BEFORE THE PUBLIC UTILITY COMMISSION

Docket No. LC 81

Avista, 2023 Natural Gas

Staff Final Comments

Figure 1: Comparison of Green Hydrogen Cost Trajectories

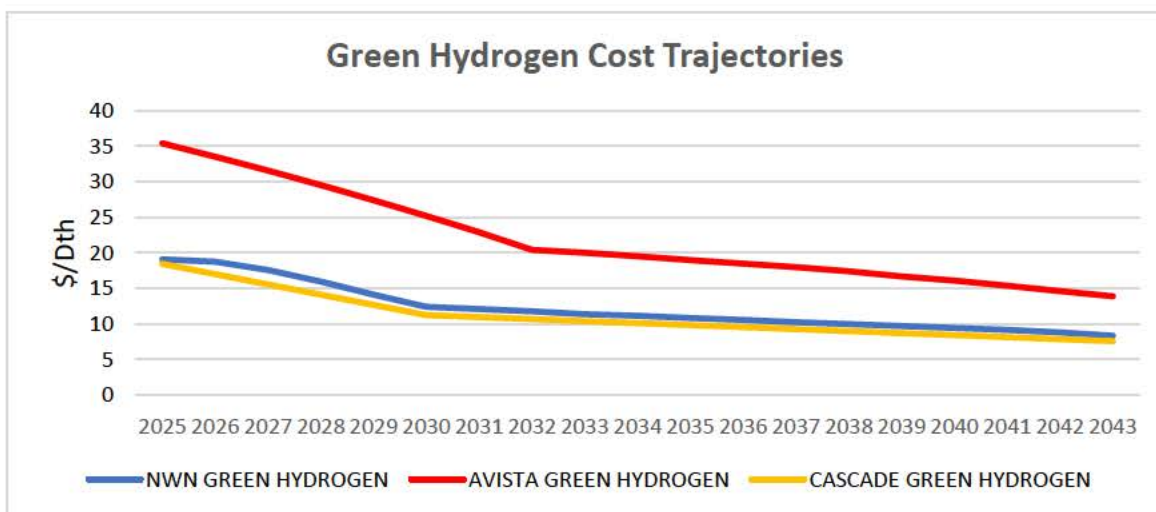
Staff agrees with CUB’s assessment of the risks associated with synthetic methane, however, differs slightly regarding CUB’s assertion that Avista needs to rely on an “established method.” Staff supports Avista’s efforts to project new supply side resource costs and availability and encourages Avista to explore and critique objective third-party sources that could be used to project costs and availability as part of the TAC process for developing future IRPs. While Avista’s estimates for green hydrogen costs as a feedstock to synthetic methane are conservative when compared against NW Natural and Cascade, as shown in Figure 1,⁷ Staff remains concerned about the Company’s ability to produce or procure the green hydrogen required to produce synthetic methane at the scale projected by Avista in its IRP.

Figure 2:
Comparison of Dairy RNG IRP Estimate and RFP Bids

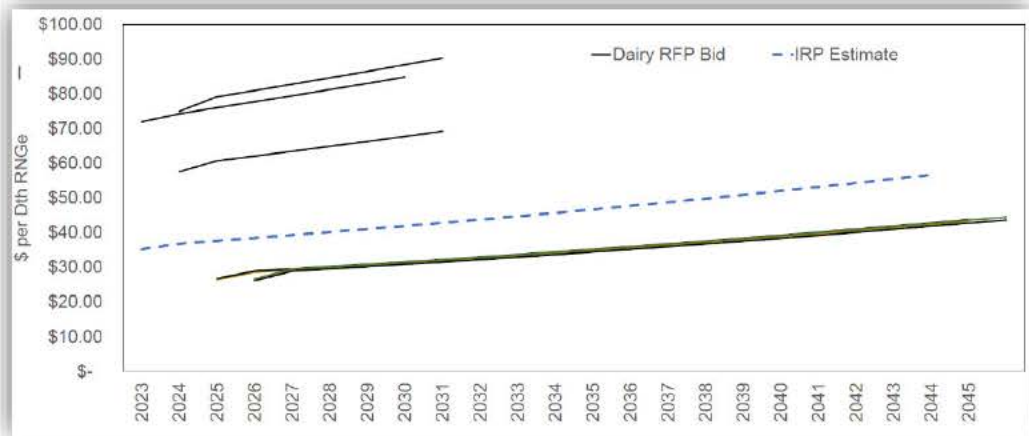
Staff agrees with CUB that the RNG pricing is unreasonably low and that this undermines the Oregon PRS and IRP long-term plan generally.²³ While RNG is not the Company’s primary CPP compliance resource, it remains a consistently large resource in the PRS, starting in the near-term and maintaining importance throughout. If the resource is being underpriced, this could have negative impacts particularly on utilization of CCI and DSM programs, each of which represent smaller portions of the resource mix. The RNG cost comparison charts provided by Avista reinforces this concern. IRP RNG pricing that does not include important market factors, including LCFS and RIN program pricing, are unreasonably low and do not accurately represent the cost of RNG, therefore, lead to RNG to potentially overcrowding the Company’s Oregon PRS
